Enclosure to ULNRC-06735

Ameren Missouri Response to NRC RAIs

On March 31, 2021, Union Electric Company, dba Ameren Missouri, submitted a license amendment request (LAR), in combination with a request for regulatory exemptions, for adopting a risk-informed approach for resolving GSI-191 and responding to Generic Letter (GL) 2004-02, for Callaway Plant. In support of the initial submittal, a number of supplements have been submitted, as identified in the cover letter of this submittal. As the U.S. Nuclear Regulatory Commission (NRC) staff is continuing to review the application, it recently determined that additional information is required in order to complete the review of the subject LAR. The NRC staff's request for additional information (RAI), consisting of two individual requests, RAI No. 1 (with two parts) and RAI No. 2, was electronically transmitted on April 5, 2022.

Figure RAI-1.1. First view of Callaway fiber insulation (Nukon™ in gold, ThermalWrap™ in tan).

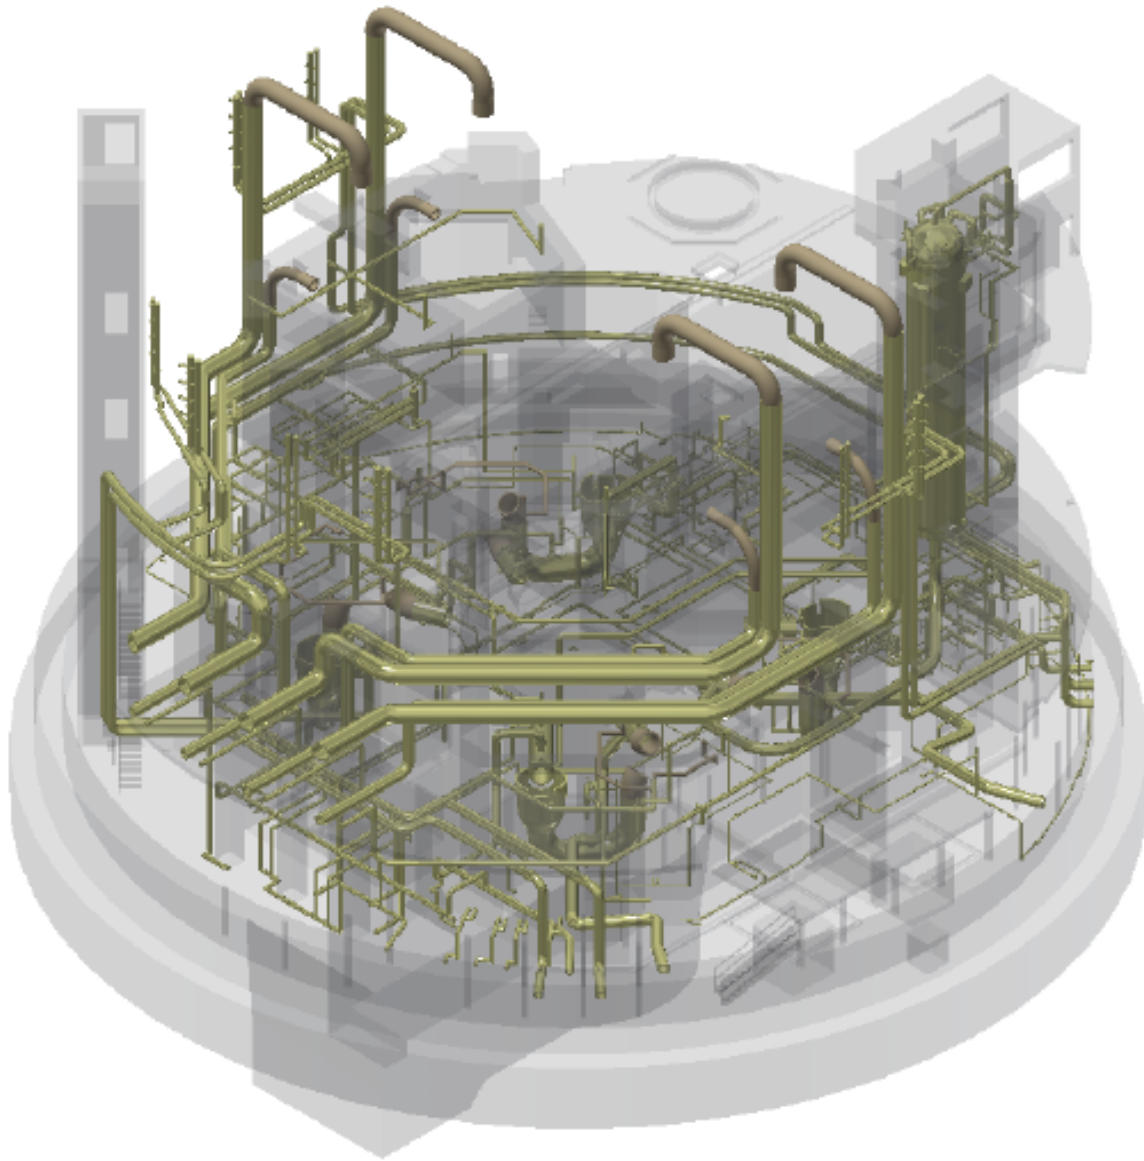
- b) Enclosure 1 also states that compliance with 10 CFR 50.46(a)(1) and the relevant General Design Criteria would entail removal and disposal of significant amounts of insulation. In order to support the staff's evaluation of potential waste management impacts, NRC requests that Ameren Missouri provide the estimated volume (cubic feet) of radiologically contaminated waste that would be generated from the replacement of the existing insulation addressed in Enclosure 1.

- b) Figures RAI-1.1 and RAI-1.2 (on the following pages) illustrate the low-density fiber glass (LDFG) insulation present in the Callaway containment building. Gold-colored jackets denote Nukon™ insulation, and tan-colored jackets denote ThermalWrap™ insulation (mostly applied to top segments of the Main Steam and Feedwater lines). These images are produced from the CAD model used/described in Enclosure 1 to the March 31, 2021 LAR (identified above and as Ref. RAI-1.3 on page 4) to address the "RoverD" risk attributed to fiber insulation. The figures illustrate that fiber insulation is present in every region of containment, including locations difficult to access that would prolong worker exposure and high-dose areas such as the Regenerative Heat Exchanger and the Letdown Valve Cubicles that are presently managed as locked high-radiation areas.

There are 5023.5 ft³ of Nukon™ and 436.1 ft³ of ThermalWrap™ in containment, giving a total LDFG inventory of approximately 5460 ft³. Assuming a manufactured density of 2.4 lbm/ft³, this volume corresponds to a total potential debris mass of 13,103 lbm, or 6.6 tons. Most of the removed insulation would be disposed of as low-level radioactive waste with varying degrees of radiation contamination and associated hazards.

Figure RAI-2.1. Containment-pressure-available history for LBLOCA.

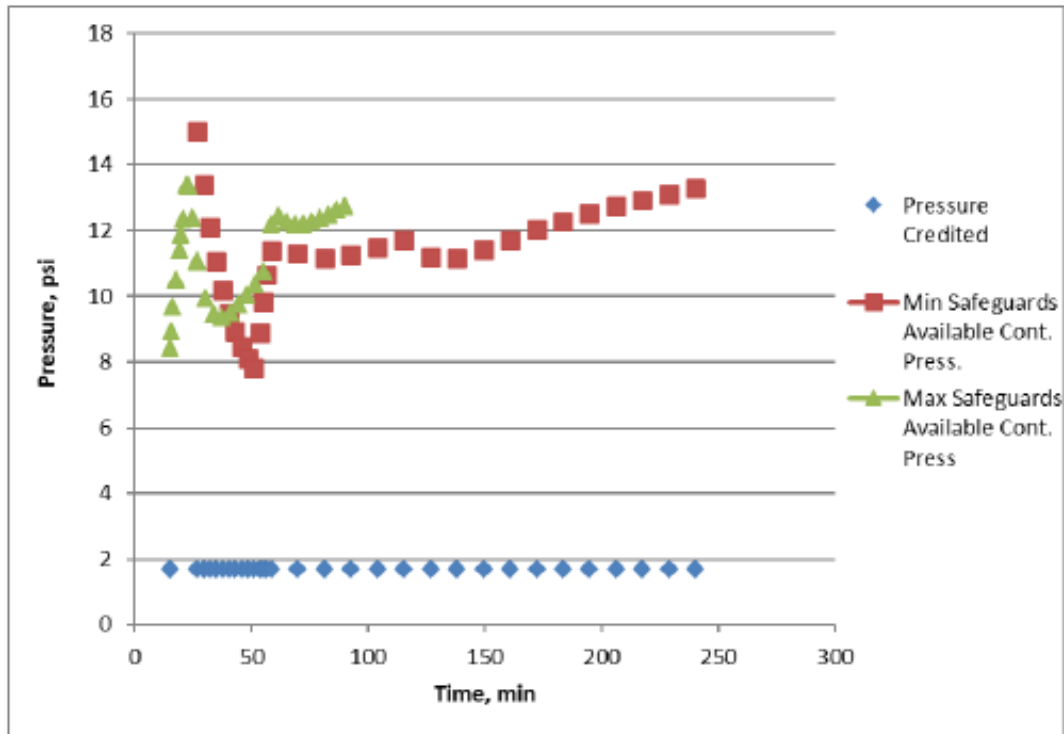
Request: Clarify whether the 10 percent value is based on the time at which the minimum margin to flashing occurs and that it is based on the pressure predictions for the LBLOCA, not the [main steam line](#) break. If it is not based on the time of minimum margin, provide the margin to flashing based on the time at which the margin to flashing is at its minimum.

Figure RAI-2.1 (next page) displays containment pressure available for a LBLOCA with minimum and maximum safeguards configurations from the time of ECCS switchover until the time when sump temperature reduces below 212 °F. Containment pressure available equals calculated absolute containment pressure reduced by saturation pressure and reduced by an additional 1.8 psi. Saturation pressure is required to maintain the fluid as a liquid, and thus, it is not available for containment overpressure credit. The further reduction of 1.8 psi is determined by reducing the calculated containment pressure of the design basis analysis from a Technical Specification maximum of 1.5 psig [References RAI-2.1 and RAI-2.2 on page 9] to the Technical Specification minimum of -0.3 psig [Ref. RAI-2.1]. In the minimum safeguards configuration, available containment pressure reaches a minimum at approximately 50 min.

Figure RAI-2.1 illustrates that during most of the minimum safeguards LBLOCA history, 1.7 psi of overpressure credit is approximately 15% of containment pressure available ($1.7\text{psi}/11\text{psi} \approx 15\%$). For approximately 30 minutes, 1.7 psi is more than 15% of the available containment pressure and reaches a maximum credit of approximately 22% at the minimum-safeguards-LBLOCA minimum available containment pressure ($1.7\text{psi}/7.7\text{psi} \approx 22\%$). When consideration is given to pump flow timing, required overpressure is reduced to approximately 10%, or less, of available containment pressure for the duration of the accident scenario (presented below).
